MEMORANDUM

Subject: DOE Comments on 881 Hillside RI/FS

Date: October 17, 1988

Figure 4. 59-86BR SANDSTONE IN PLAN

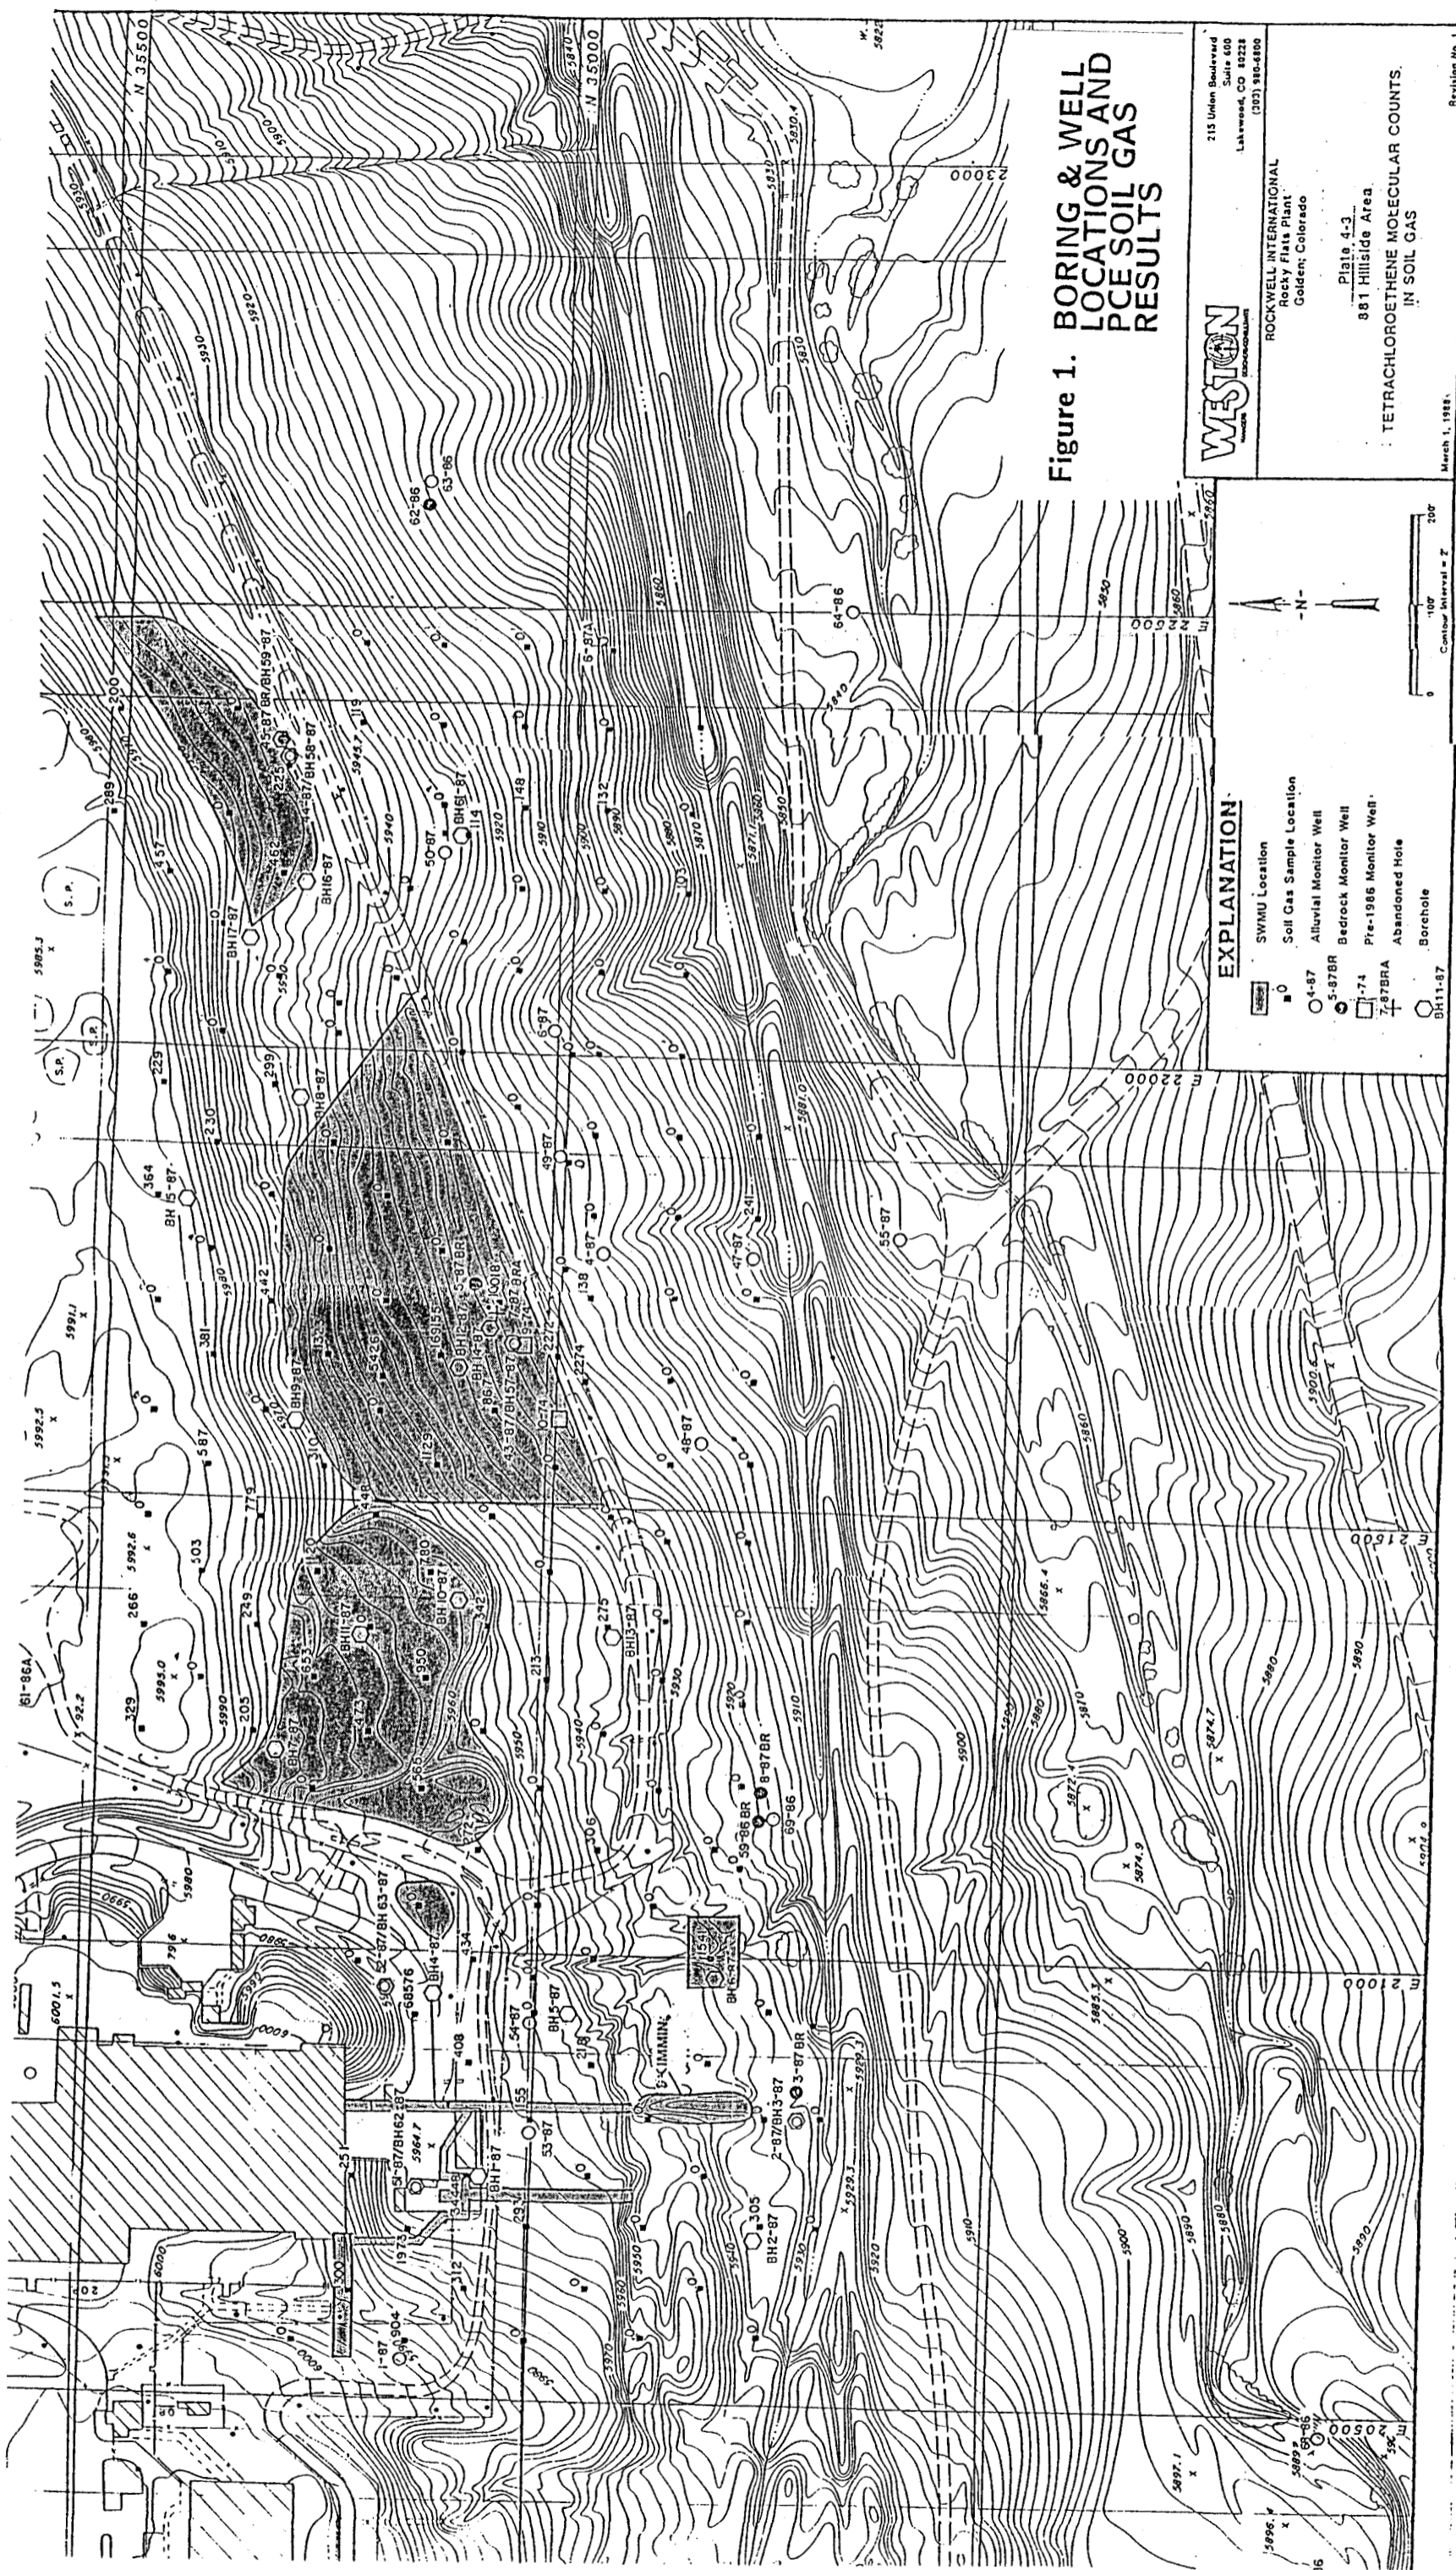
A primary concern with the work done to date at the 881 Hillside is the degree to which the potential for bedrock contamination, both current and future, has been evaluated. The discussion in Section 5.4.3.1 indicates elevated uranium in the uppermost bedrock aquifer at 59-86BR as well as similar groundwater chemistry and selenium concentration to the overlying alluvial groundwater. Considering the proposal to leave waste in place and treat alluvial groundwater, a subcropping sandstone aquifer in the vicinity of Building 881 has a potential for bedrock contamination during the operational life of the treatment facility. Consideration should be given to placing one or two shallow bedrock aquifer wells down-gradient and slightly east of the three well cluster to indicate if suspected bedrock contamination persists down-gradient and down-dip. Also a concentrated geophysical survey combined with a limited number of boreholes in the area bounded by boreholes 59-86BR, BH63-87, BH53-87 and

BH3-87 could be implemented to specify the suspected area of bedrock/alluvium communication.

Nonetheless, the RI team shares the concern expressed by the reviewer with regard the evaluation of bedrock contamination. Detailed discussions together with supporting data are presented in the RI dealing with the evaluation of chemical conditions in the bedrock. The essence of the discussions is presented in Table 4 and can be summarized as follows.

1. At SWMU 119.1, bedrock ground water is distinctly different from colluvial ground water (based on major ion, uranium and organic differences); therefore, colluvial ground water is in poor connection with bedrock ground water and there is little potential for impact to the bedrock ground water.
2. At SWMUs 103, 106 and 107 (south of Building 881), deeper bedrock ground water is distinctly different from colluvial and shallowest bedrock ground water (based primarily on uranium differences); however, shallowest bedrock ground water cannot be differentiated from colluvial ground water and the two systems appear to be well connected based on chemical similarities. The effects of lithologic variation

3. Although the colluvial and shallowest bedrock ground waters appear connected at the three well cluster, neither of these waters is contaminated. Uranium is the only constituent that could be considered a contaminant, and it is not considered to be a problem because the concentrations are low (less than even the proposed drinking water standard) and because it appears to be natural uranium rather than either enriched or depleted uranium.

Based on these observations, the RI team concluded that there is currently no bedrock ground-water contamination.

The potential for future degradation of water quality in the shallow sandstone at the three well cluster is considered minimal because of the location of the french drain. The connection between the shallowest bedrock ground water and the colluvial ground water is presumed to be at the subcrop of the sandstone. Based on a seven degree dip to the east, the sandstone subcrops slightly east of BH6-86 (Figure 3). Figure 4 shows the presumed location of the subcrop in plan view, together with the location of the french drain. If the sandstone were continuous, there is potential for future impact to the bedrock system. However, the drain alignment has been drilled since preparation of the RI (Figure 5 shows boring locations as presented in Aguirre, 1988), and all of the borings found claystone bedrock. Therefore, it is concluded that the sandstone is not sufficiently extensive to present a potential conduit for flow of contaminated water from areas upgradient of the french drain into the bedrock system.
